April 3, 2024

IDEA Public Schools Upper RGV Mechanical Upgrades CSP#23-URMU-0424

ADDENDUM NO. 2

SHEET: ME3.2

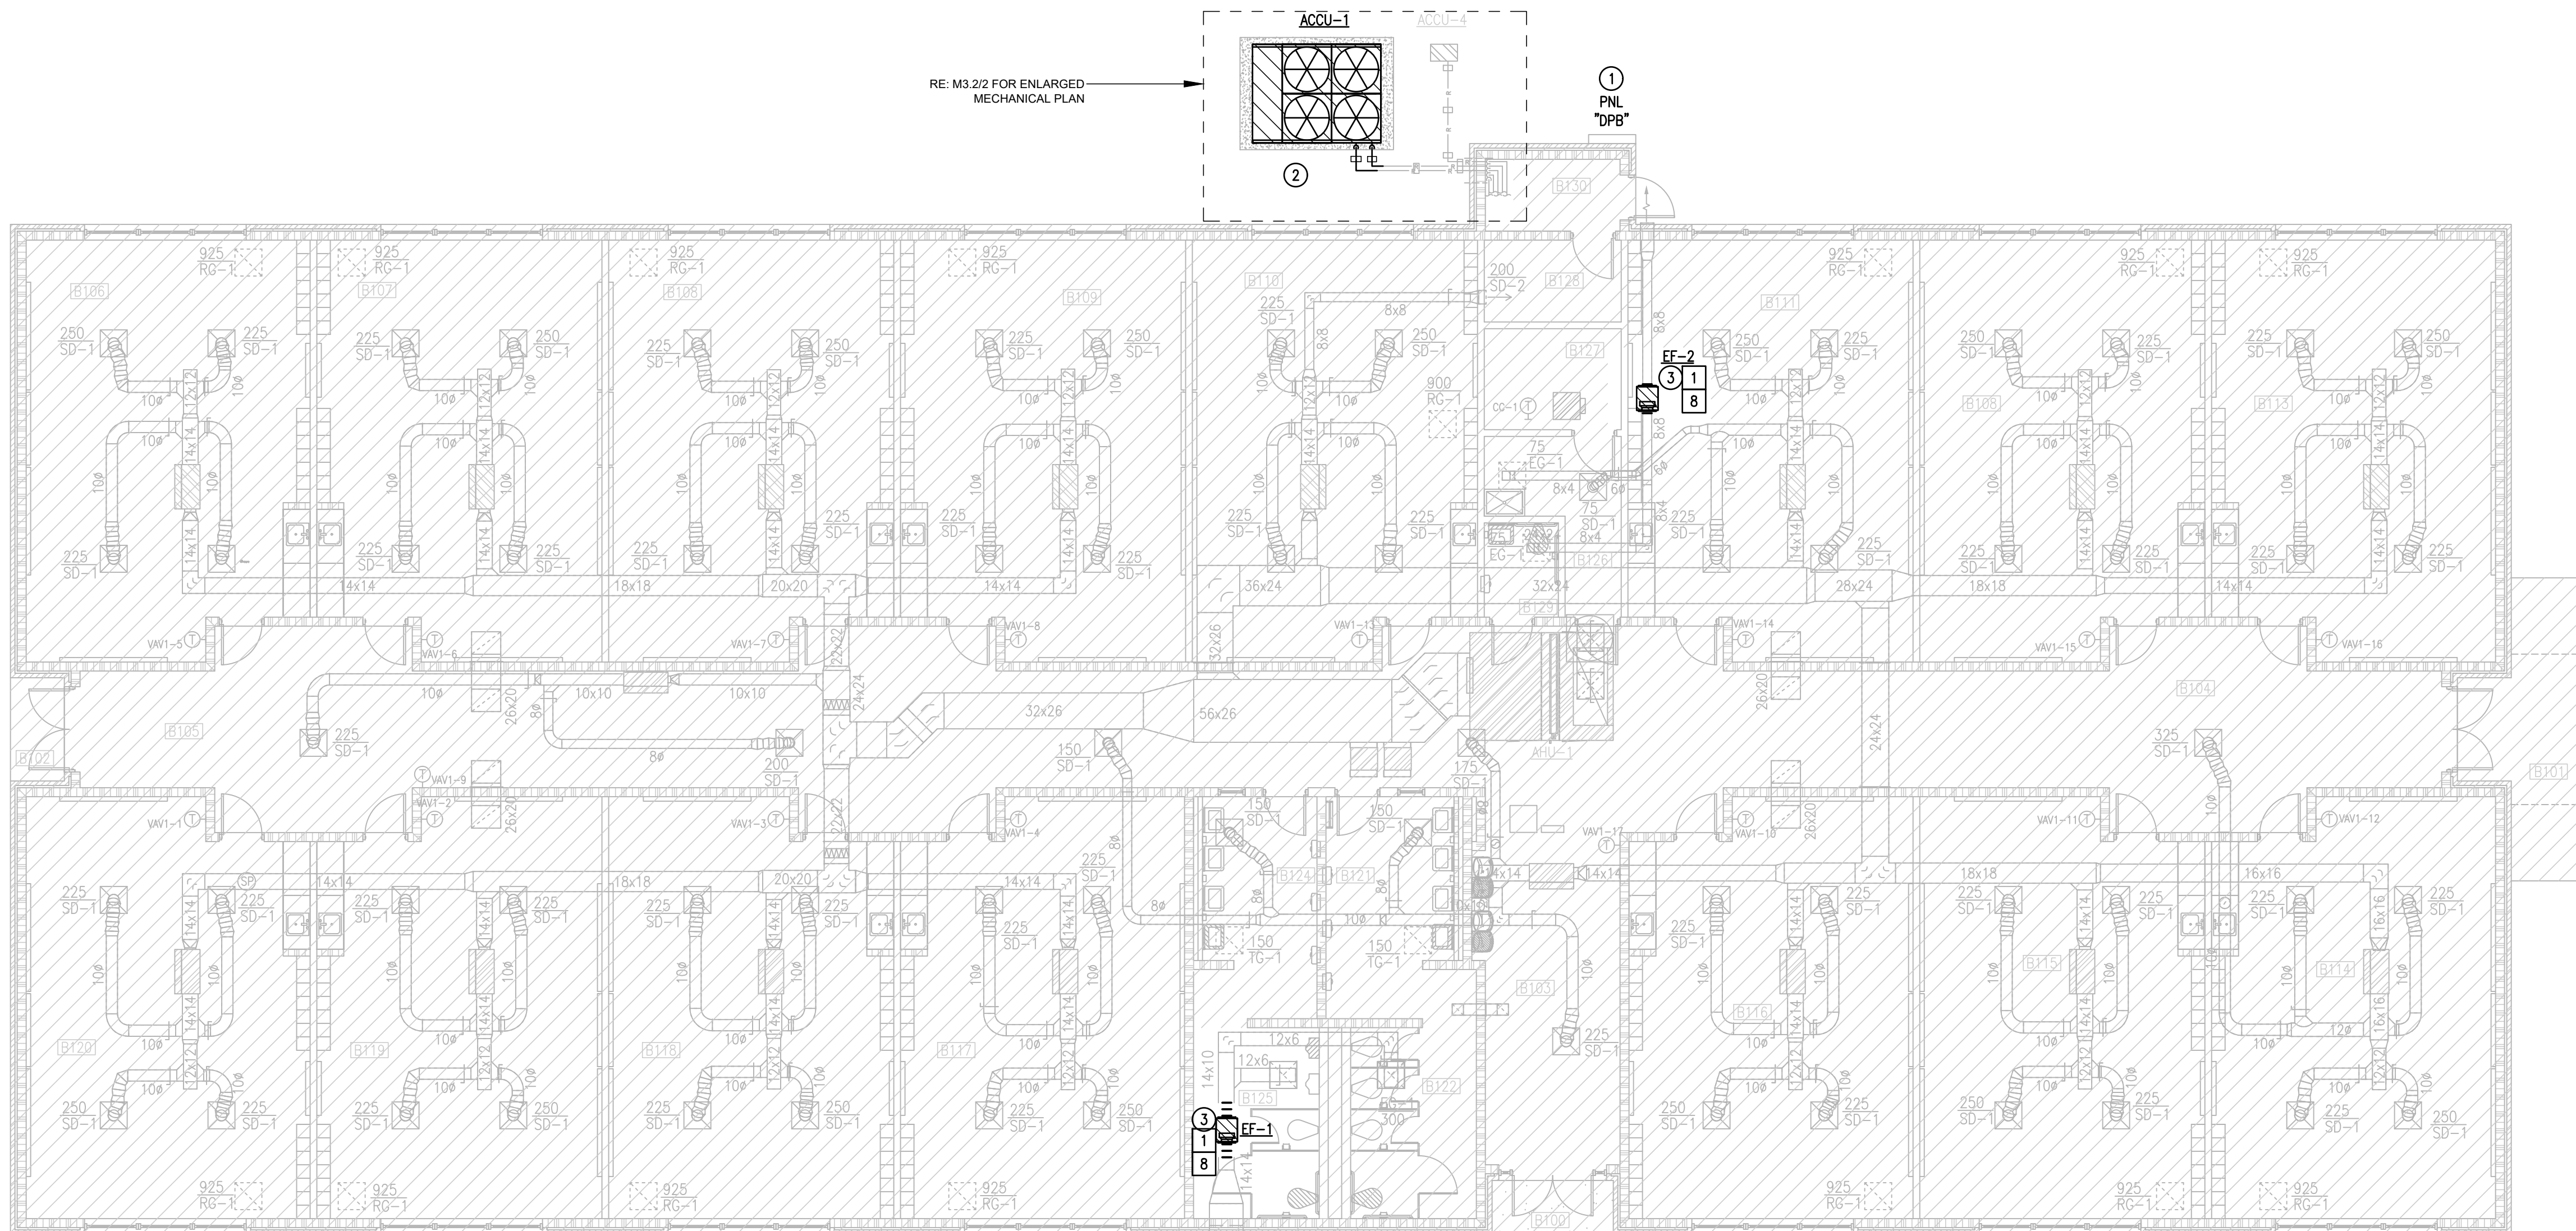
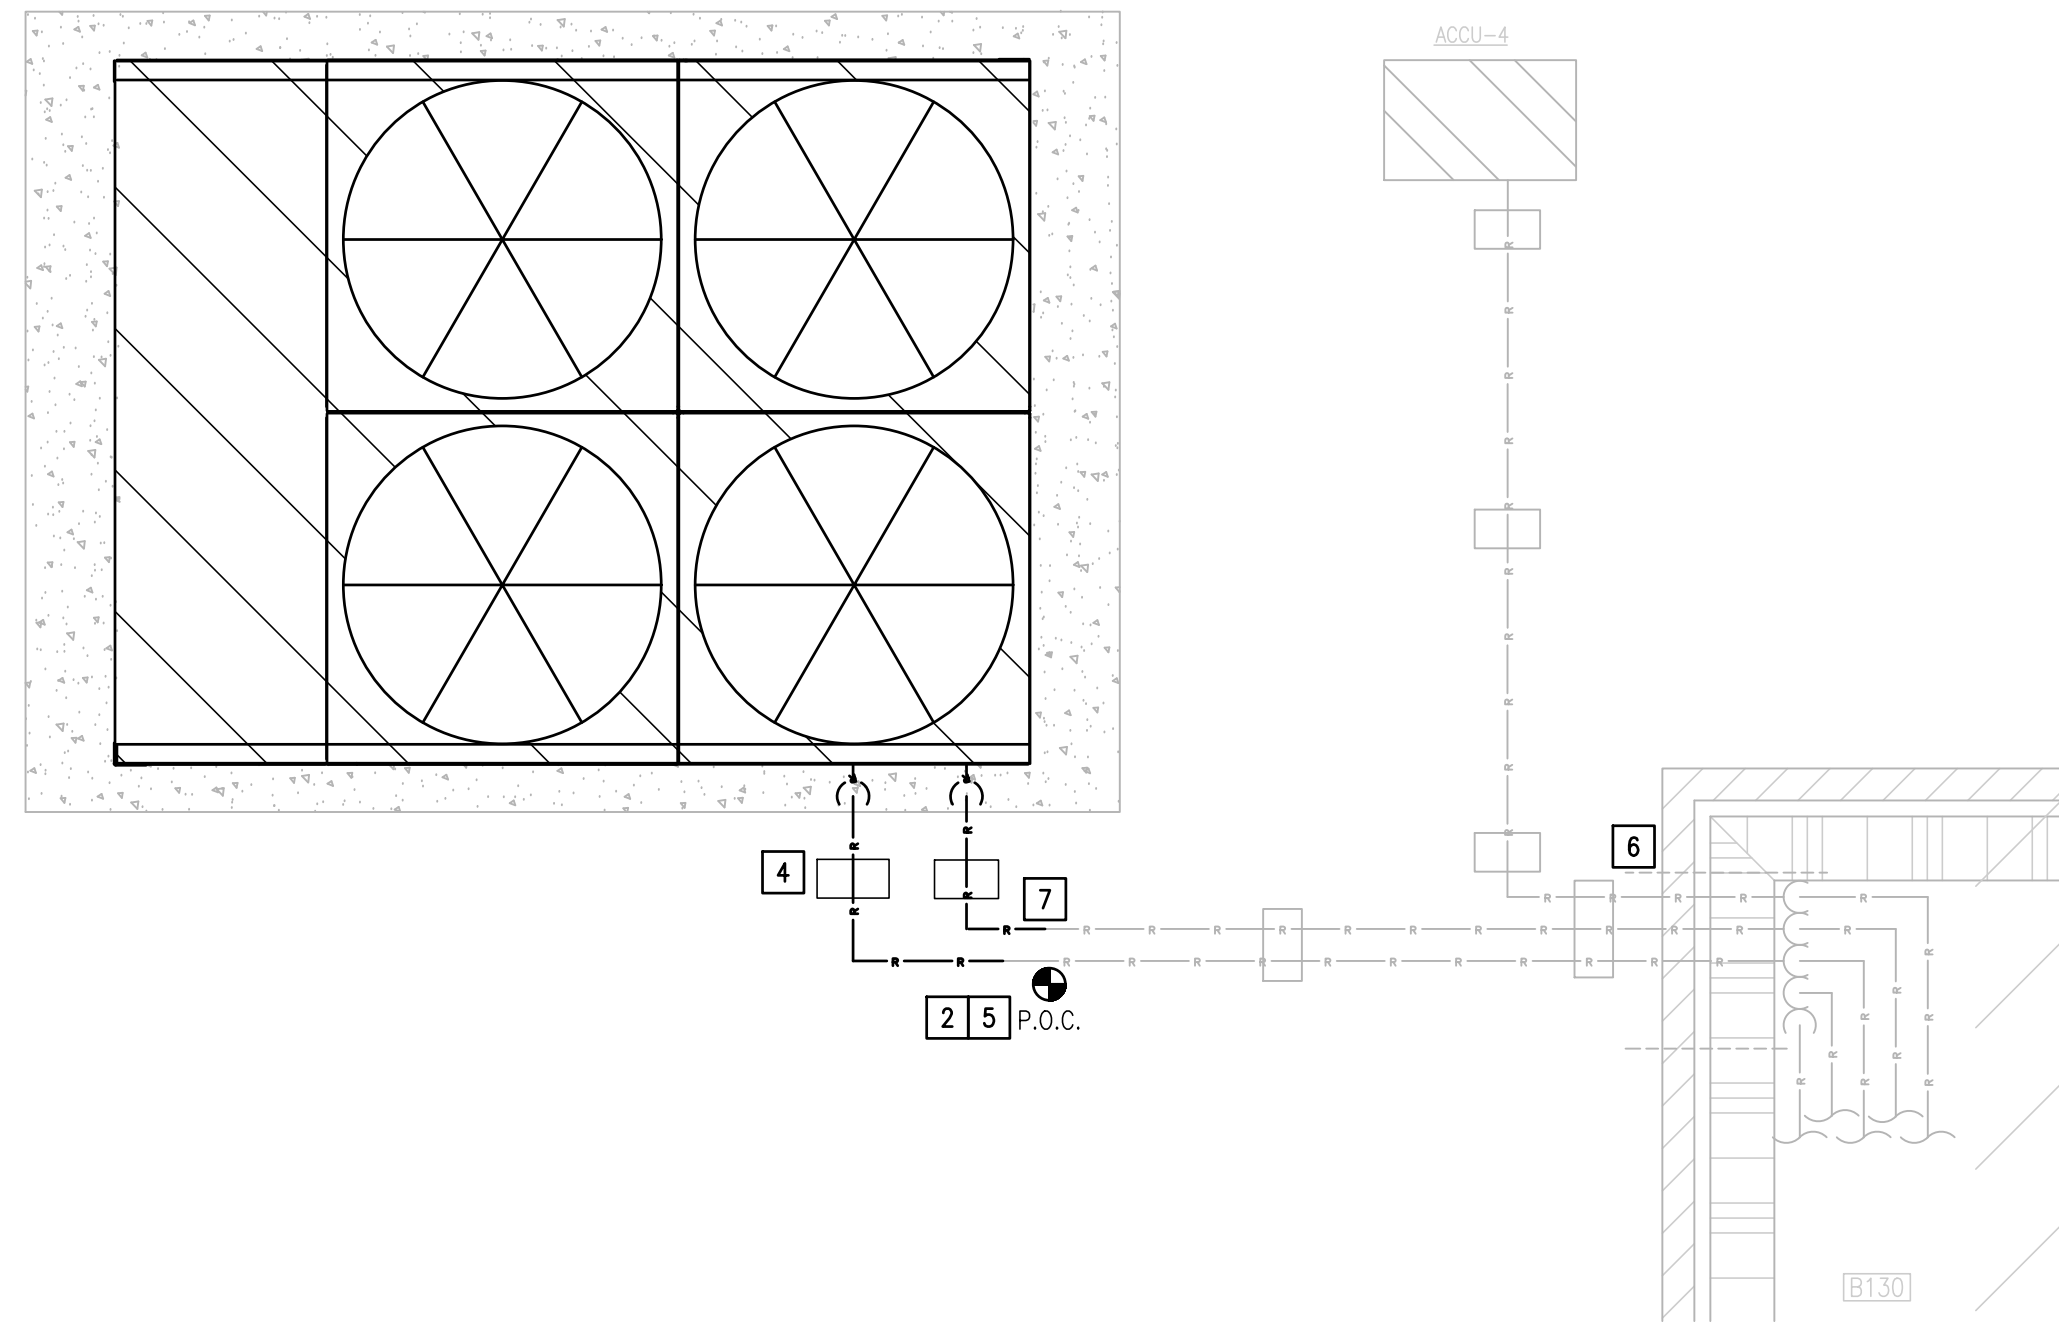
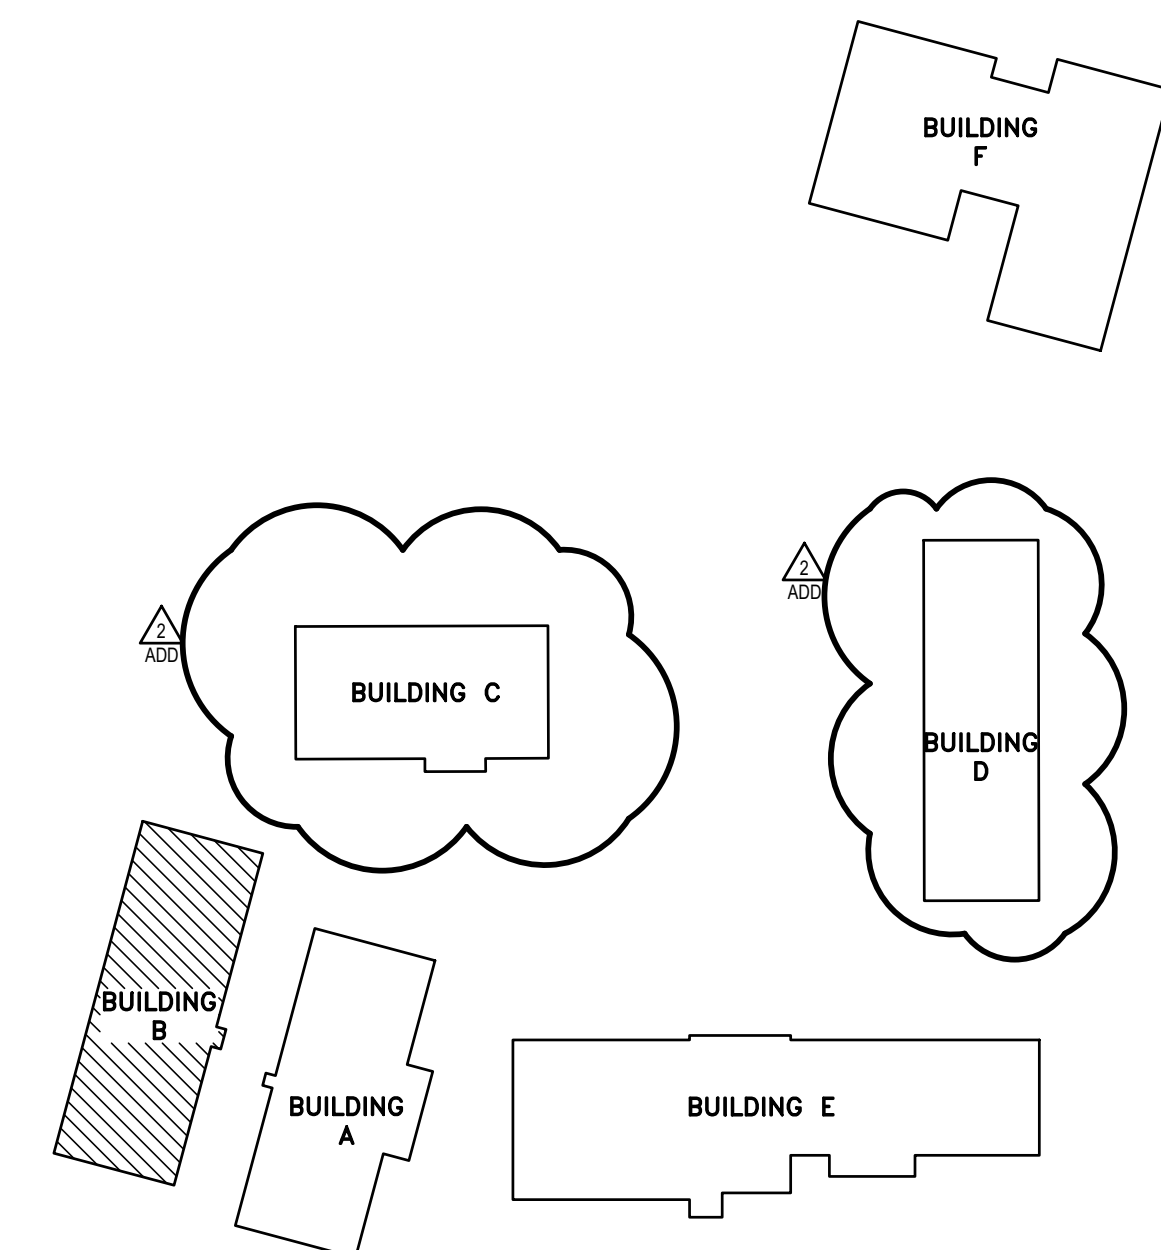
3. Sheet ME-3.1
 - a) Removed from scope; omit sheet from set.
4. Sheet ME-3.2 – See attached.
 - a) Added Base Bid identification to schedules.
 - b) Updated keyplan.
